MEMORANDUM

PLANNING COMMISSION MEETING

Agenda Planning Commission

City of Decatur, AL

CERTIFICATE TO SUBDIVIDE NO. 3323-16

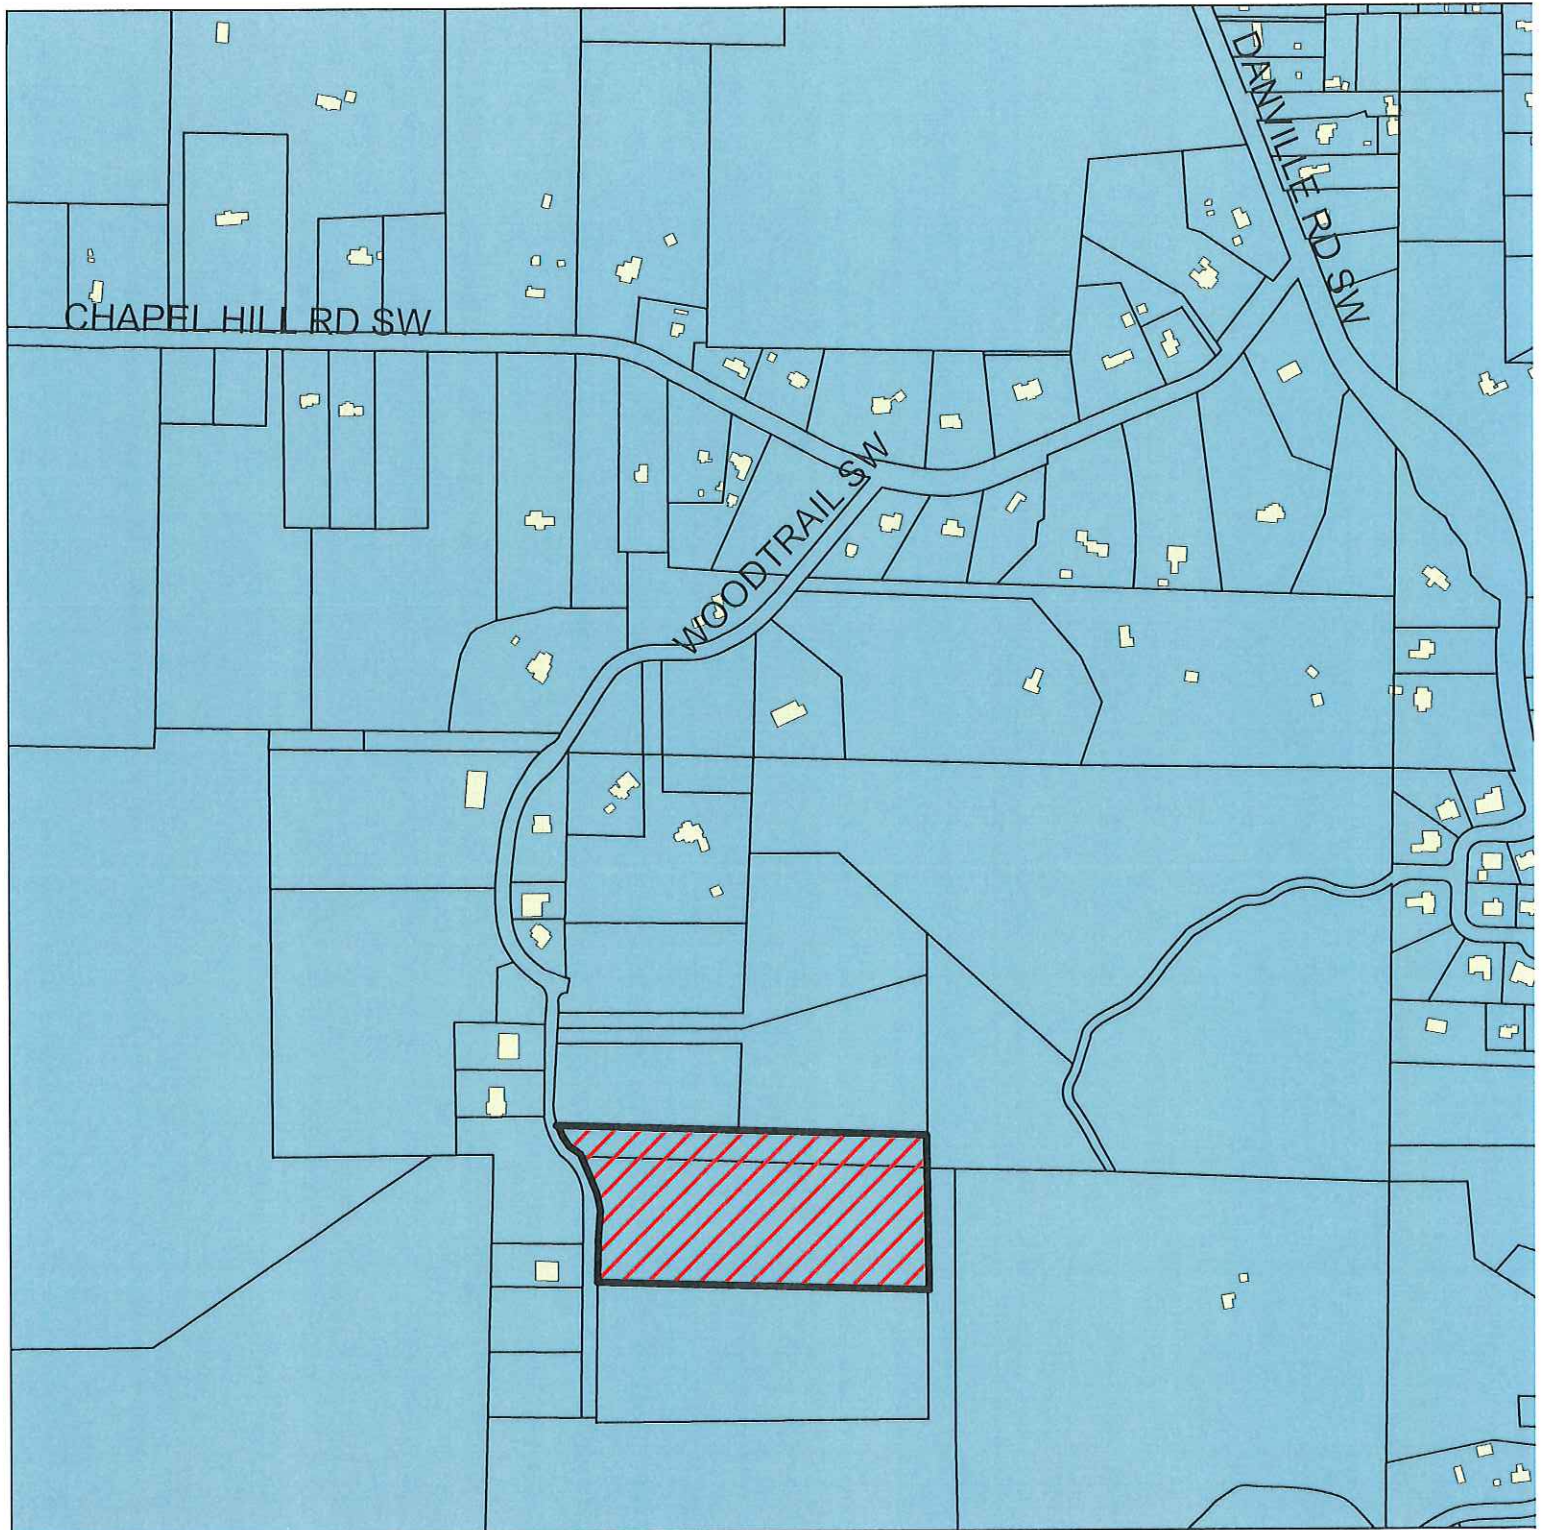
- Conds:
1. Payment of recording fees
 2. Amend survey to show existing electric & gas easements – per DU

CERTIFICATE TO SUBDIVIDE NO. 3325-16

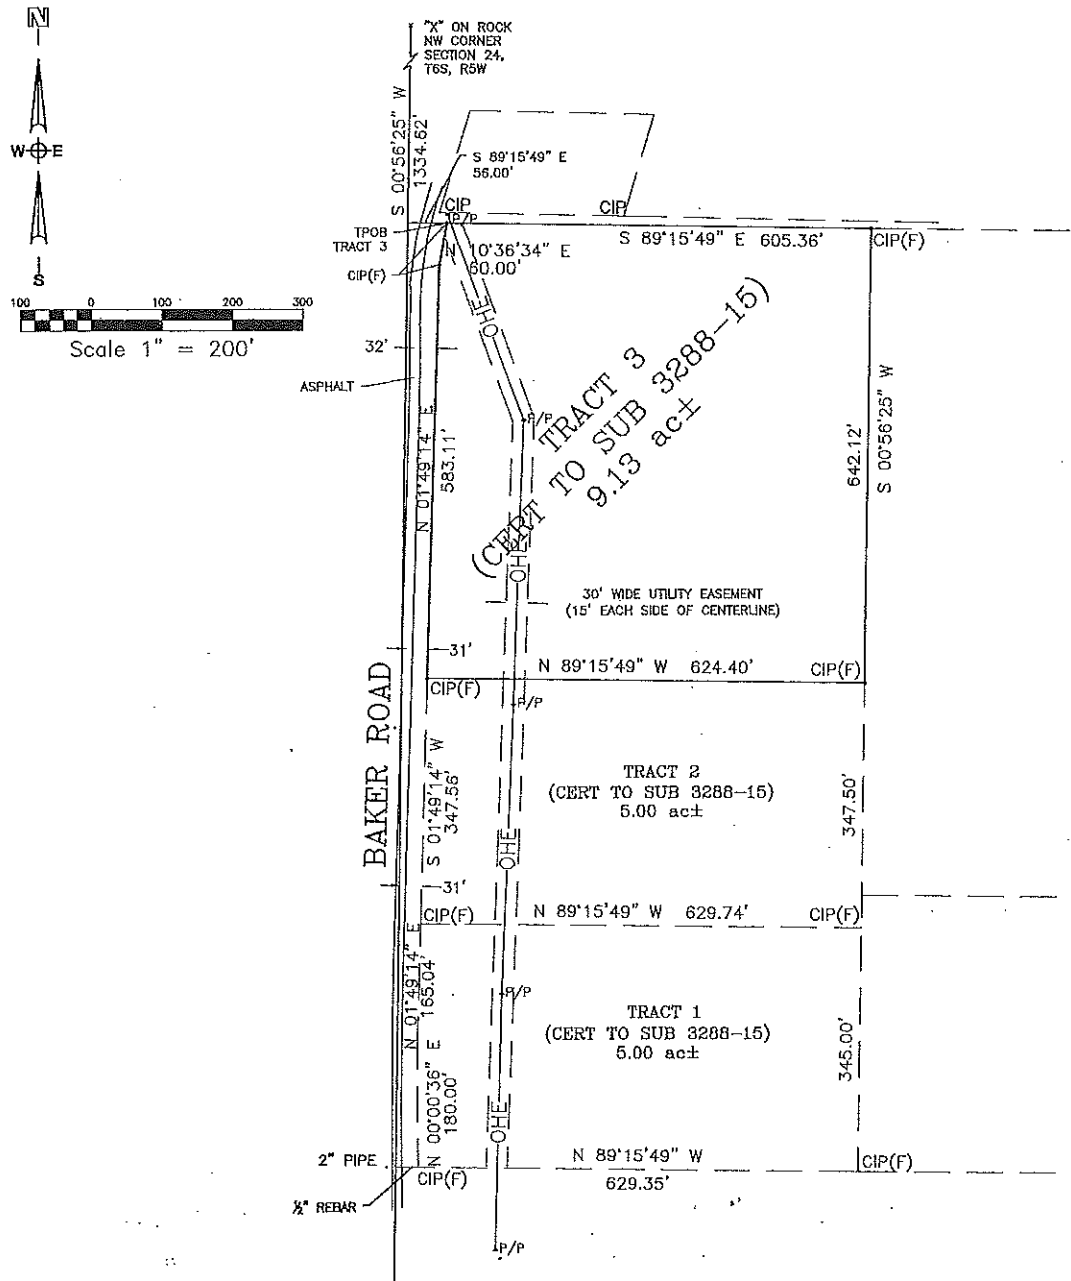
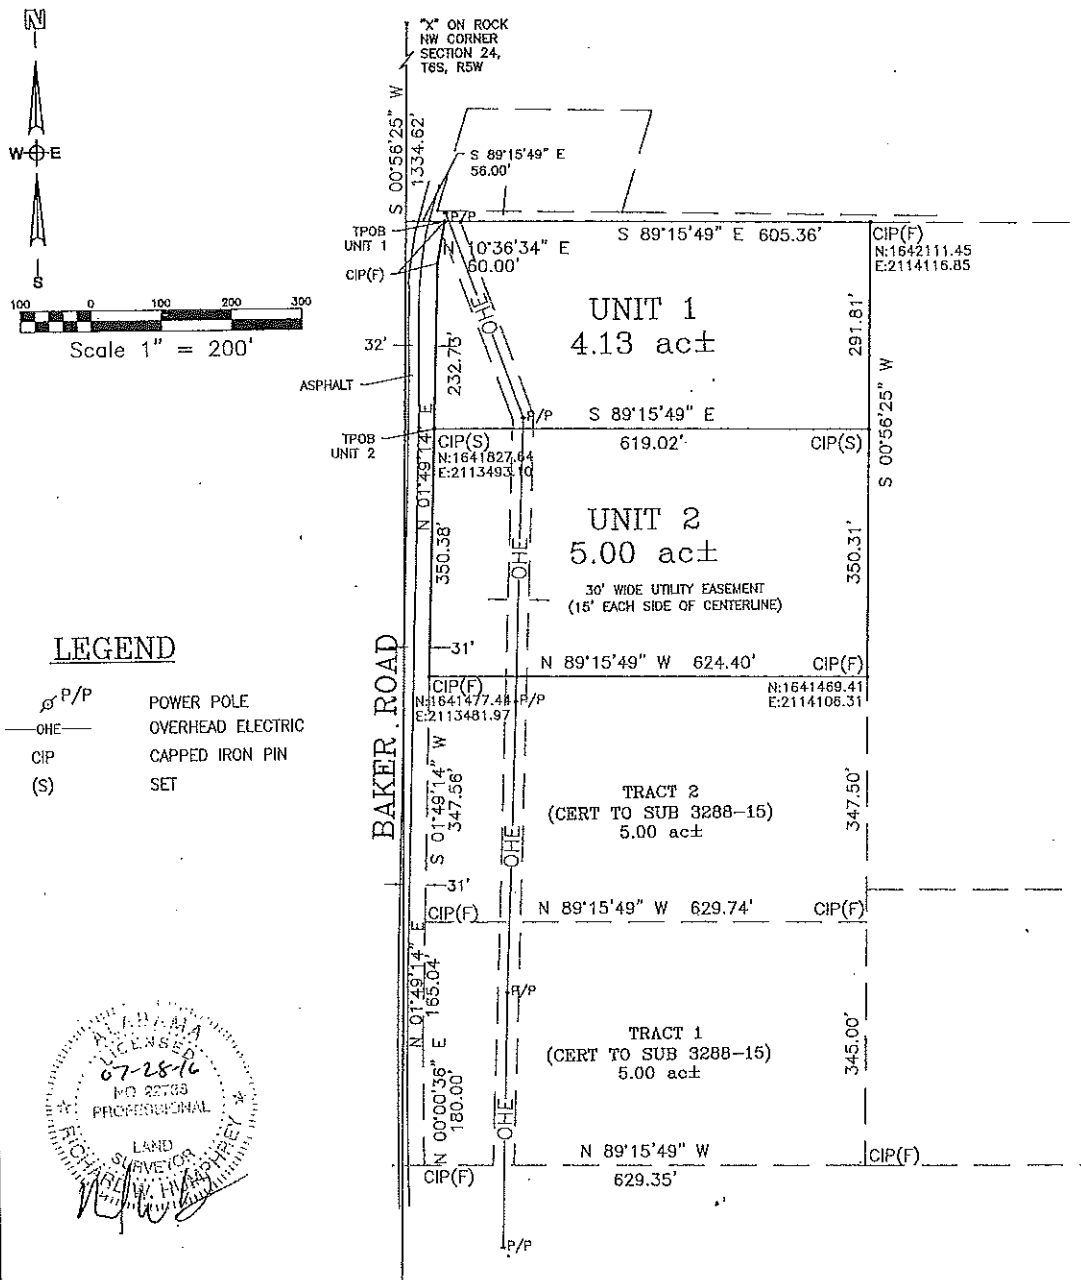
- Conds: 1. Payment of recording fees
 2. Amend survey to show new Baker Rd. ROW

CERTIFICATE TO CONSOLIDATE AND SUBDIVIDE NO. 3326-16

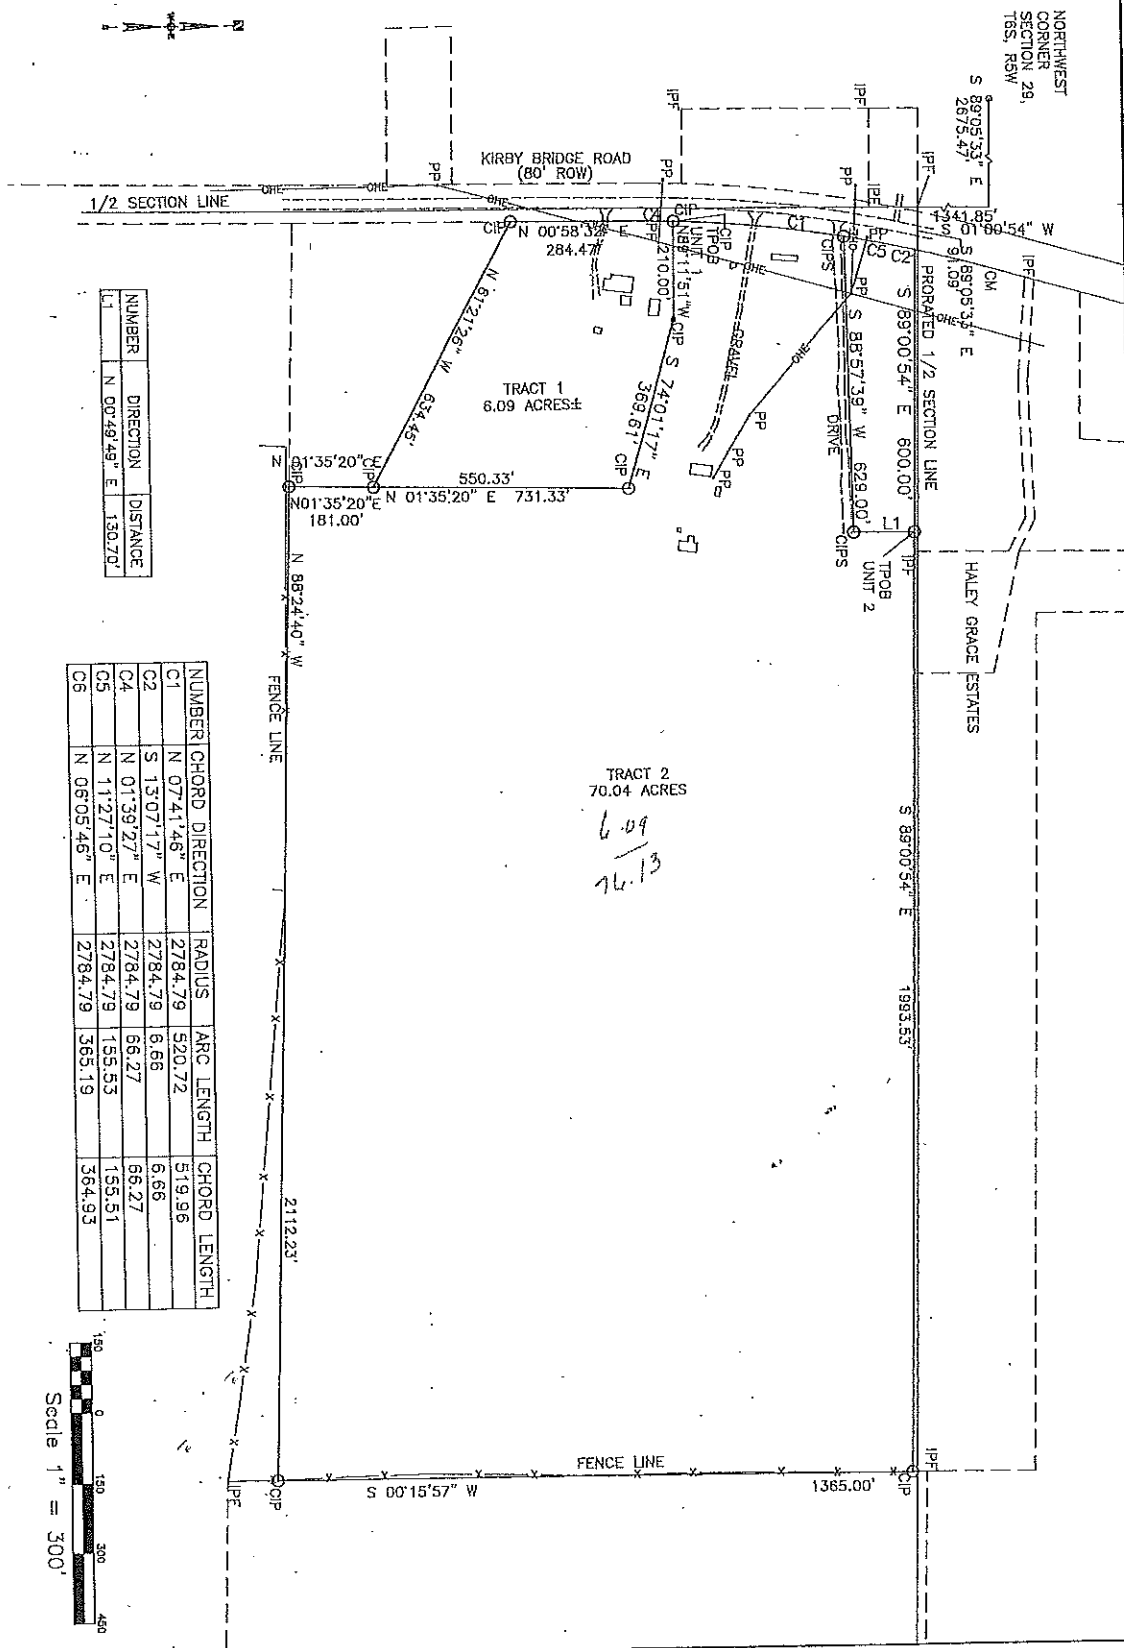
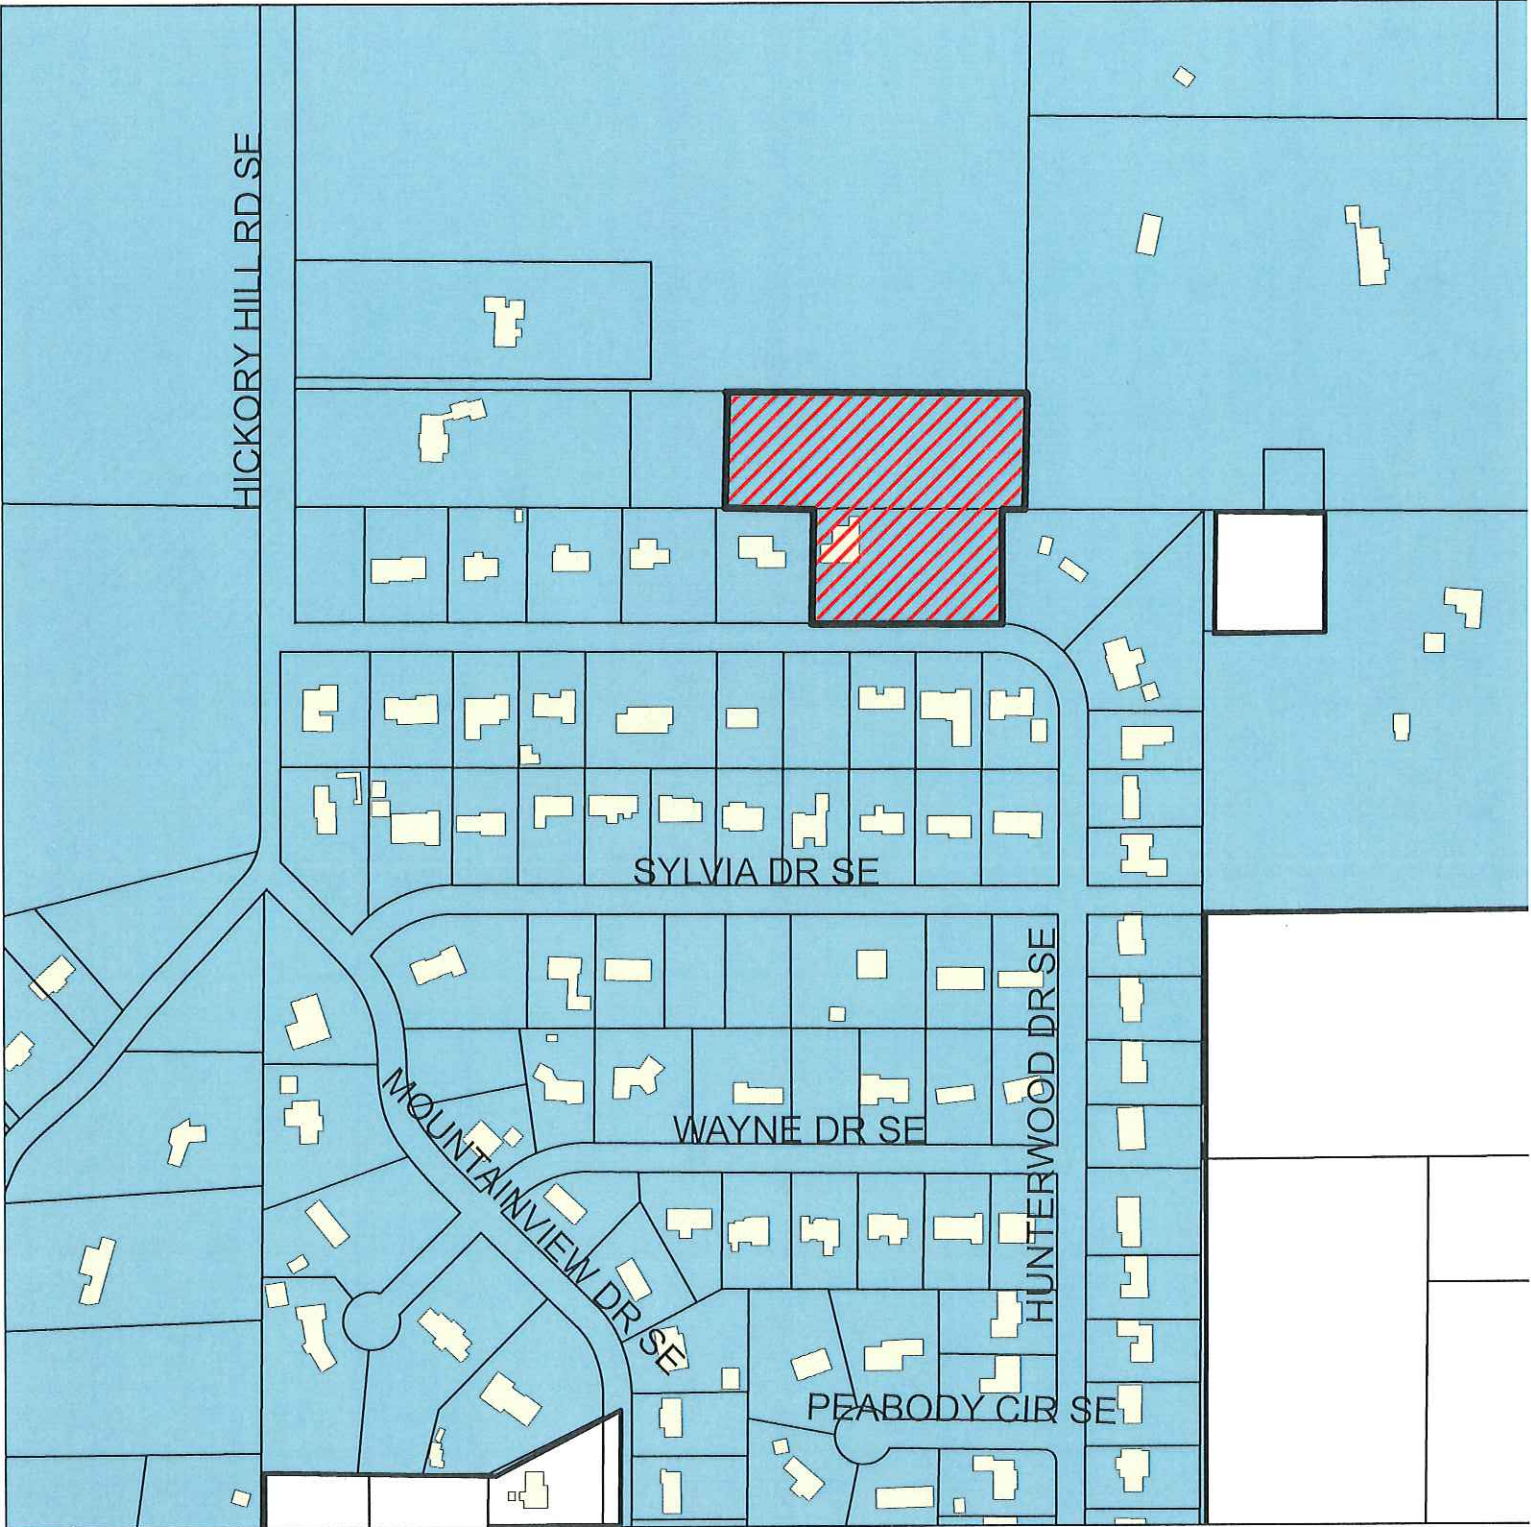
- Conds: 1. Payment of recording fees
 2. Provide a stamped and sealed survey for recording
 3. Verify/obtain septic tank approval for Unit 1
 4. Amend page 2 of certificate with proper wording for PJ and correct spelling of
 Kirby Bridge Road on page 4
 5. Provide electrical easements –to be reviewed & approved by Joe Wheeler
 Electric
